# **DART SERVICE INSTRUCTION**

TO AMEND INSTALLATION INSTRUCTIONS IIN-D412-698 REV. E & INSTRUCTIONS FOR  
CONTINUED AIRWORTHINESS ICA-D412-698 REV. 5

REF. TCCA STC SH92-43

**FIGURE 1 – INSTALLATION OVERVIEW**

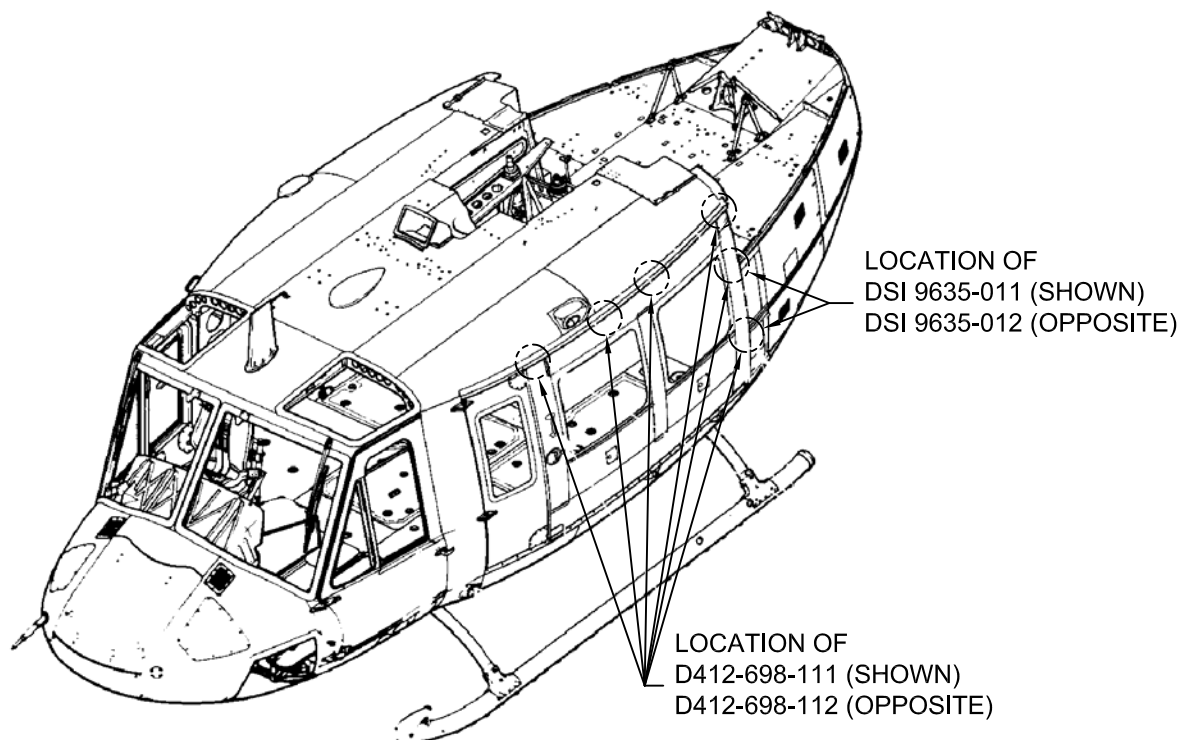
- 2.1 Remove LH and/or RH sliding doors (ref P/N 205-031-669-15/-16) from the aircraft per the Aircraft Maintenance Manual.
- 2.2 Remove 205-031-436-001 and replace with D3121-141 Bracket (3 places). Reuse existing hardware and shims if determined to be airworthy. Alternatively, if using D412-698-021 Replacement Shim Kit, install D3238-1 & D3238-11 as required. Note that the D3121-141 brackets contain one additional middle slot not used for this installation (see Figure 6 of IIN-D412-698 or Figure 52-8 of ICA-D412-698).

- 2.3 Remove 205-031-435-001/002 and replace with D3121-143 Bracket for left hand doors and D3121-144 Bracket for right hand doors. Reuse existing mounting hardware and shims if determined to be airworthy. Alternatively, if using D412-698-021 Replacement Shim Kit, install D3238-3 & D3238-13 as required. Note that the D3121-143/-144 brackets contain one additional middle slot not used for this installation (see Figure 2 of this service instruction).

- 2.4 Remove 205-031-433-1 Roller Support (LH) and 205-031-433-2 Roller Support (RH) and replace with D4737-043 on left hand doors and D4737-044 on right hand doors. Reuse existing mounting hardware and shims if determined to be airworthy. Alternatively, if using D412-698-021 Replacement Shim Kit, install D3238-5 & D3238-15 as required.

- 2.5 Remove 205-031-434-1 Roller Support and replace with D4737-041. Reuse existing mounting hardware and shims if determined to be airworthy. Alternatively, if using D412-698-021 Replacement Shim Kit, install D3238-5 & D3238-15 as required.
